**ADDENDUM NO. 03
September 26, 2022**

**WINDSONG ELEMENTARY SCHOOL ADDITION & RENOVATION ISSUE FOUR PROPOSAL
FOR FRIENDSWOOD I.S.D.**

Prepared by: PBK
11 Greenway Plaza, 22nd Floor
Houston, TX 77046-1104
PBK Project No: 20380

02 MECHANICAL HEATING WATER PIPING DIAGRAM - ADDITION
SCALE: NONE

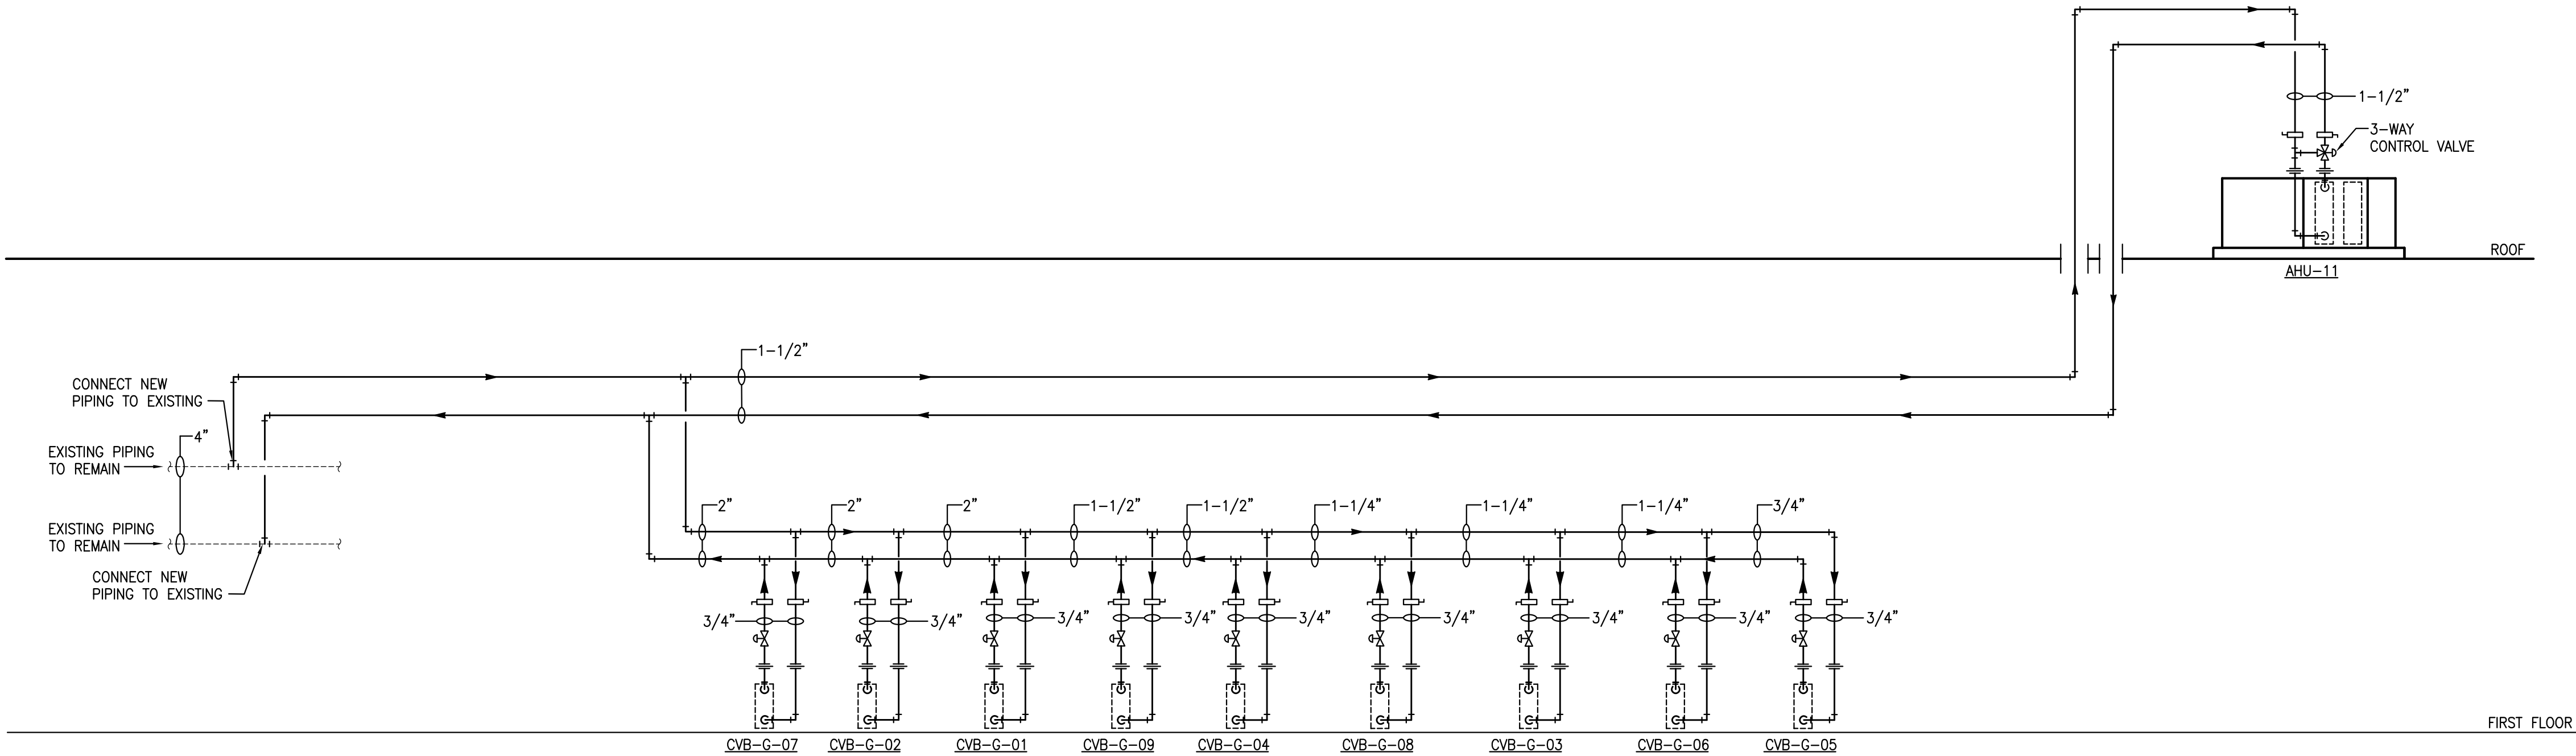
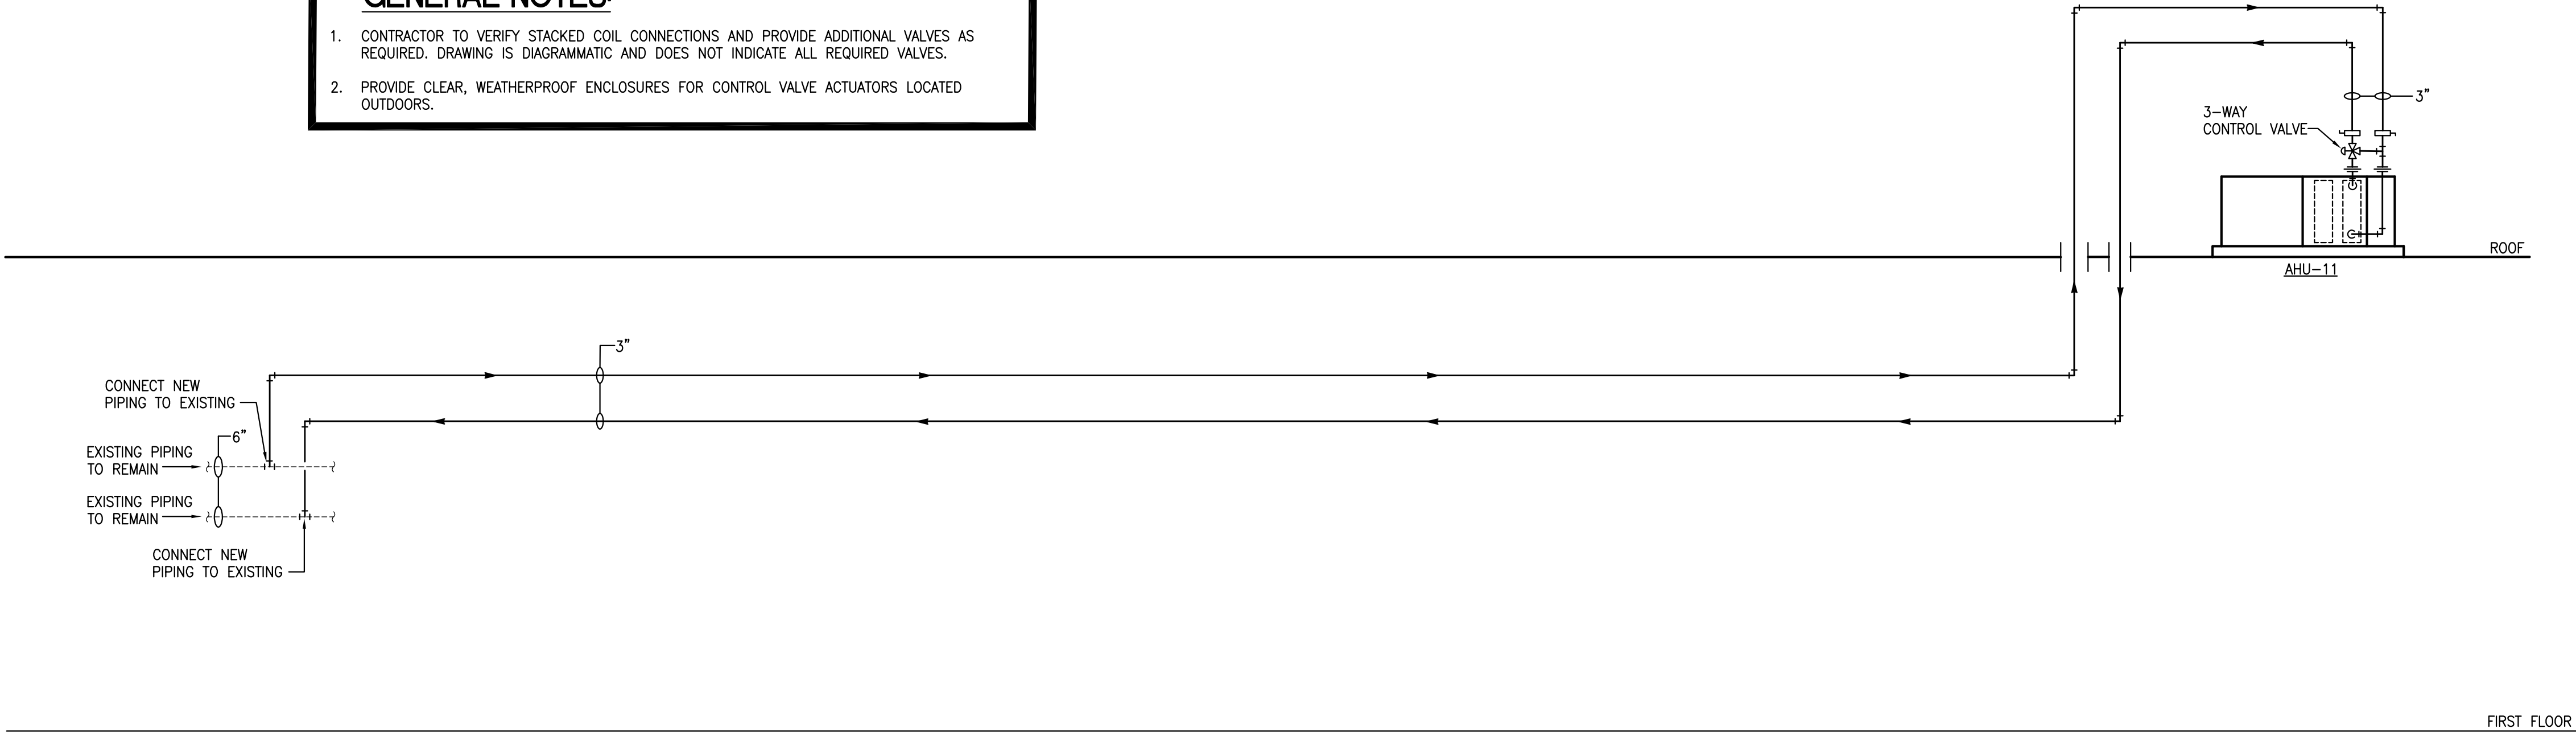
- Item No. 81 **SHEET M-401 – MECHANICAL PIPING DIAGRAM**
A. Added new sheet.
- Item No. 82 **SHEET M-501 – MECHANICAL SCHEDULES**
A. Mini-Split System Air-Conditioners Schedule:
